# West Burton Solar Project

### Figure 8.18.3: Landscape and Ecology Mitigation and Enhancement Measures West Burton 3 Revision B

Prepared by: Island Green Power  
October 2024

PINS reference: EN010132  
Document reference: DEC/WB6.4.8.18.3\_B  
APFP Regulation 5(2)(a)

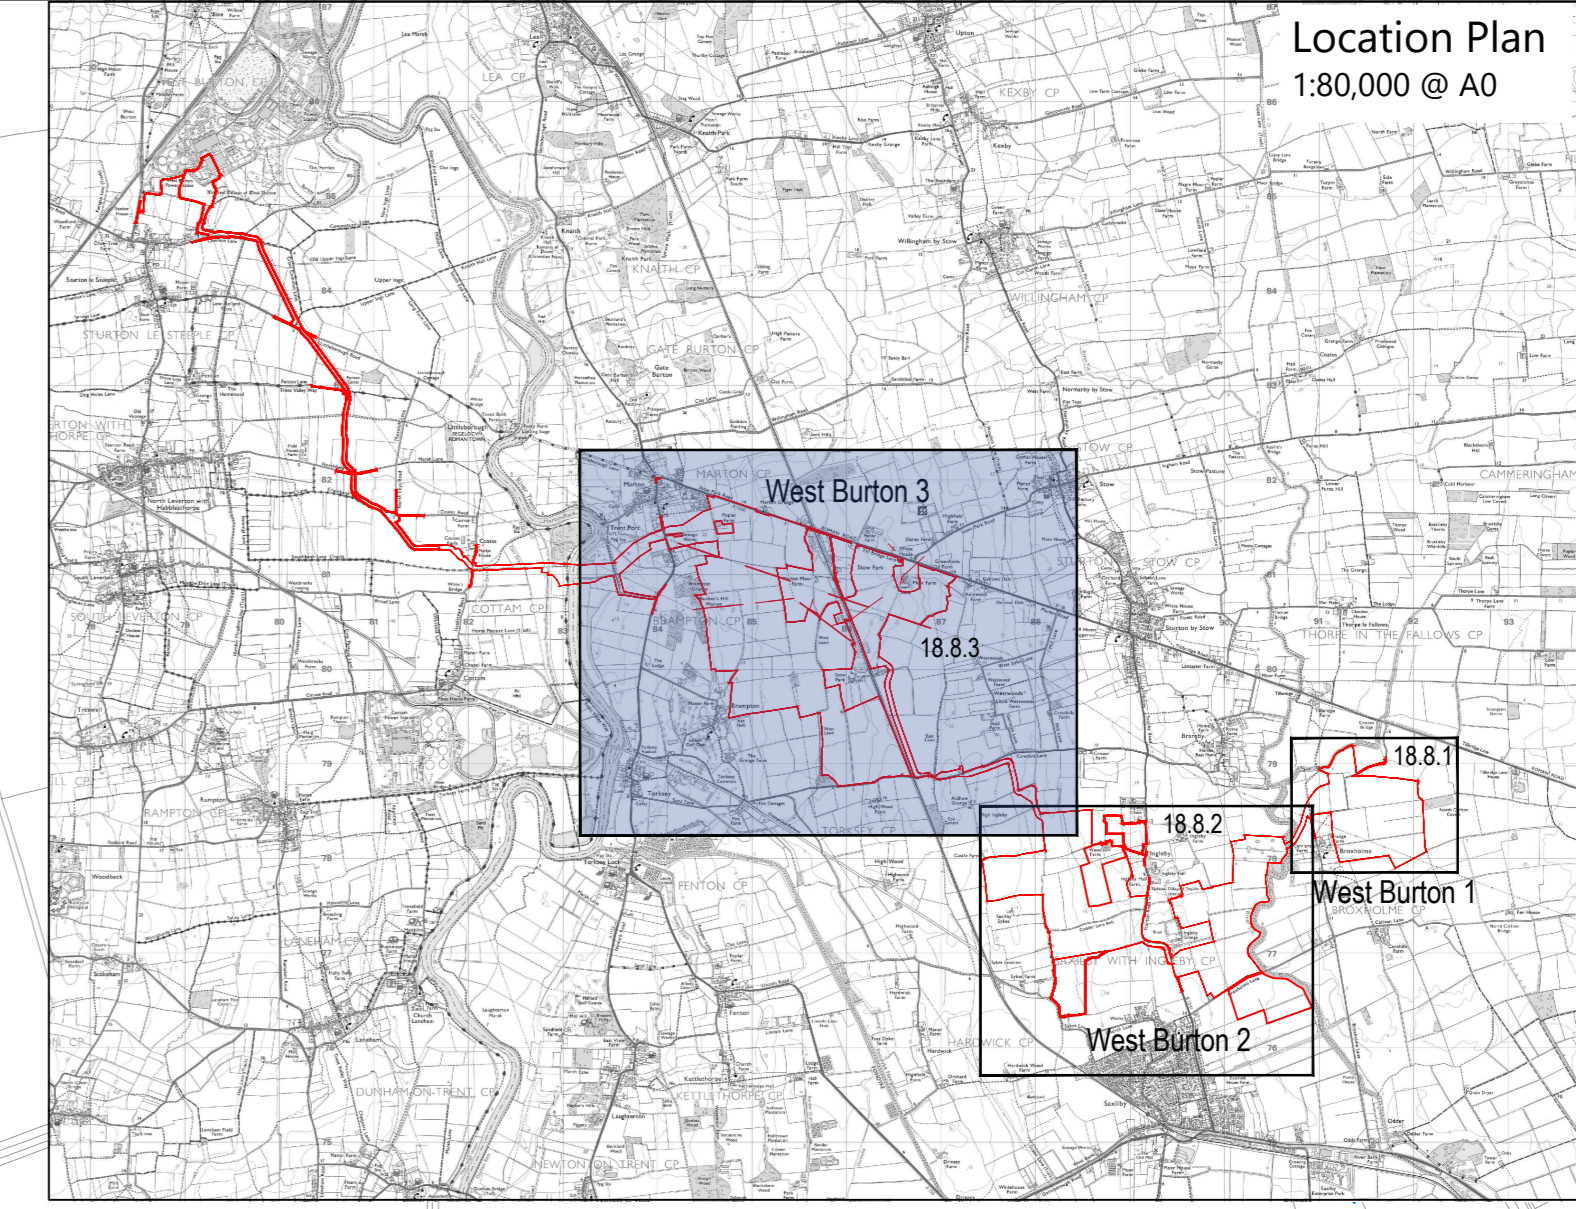
Figure Reference	Page	Description of Changes	Reason for Revision
WB6.4.8.18.3_B	3	Removal of solar panels, associated infrastructure and soft landscaping from Stow Park Deer Park (the following fields: part of P1, P2, P3, part of P4, part of P5, P6, Q24, Q25, Q26, Q27).	In response to Request for Information 1 from the Secretary of State.
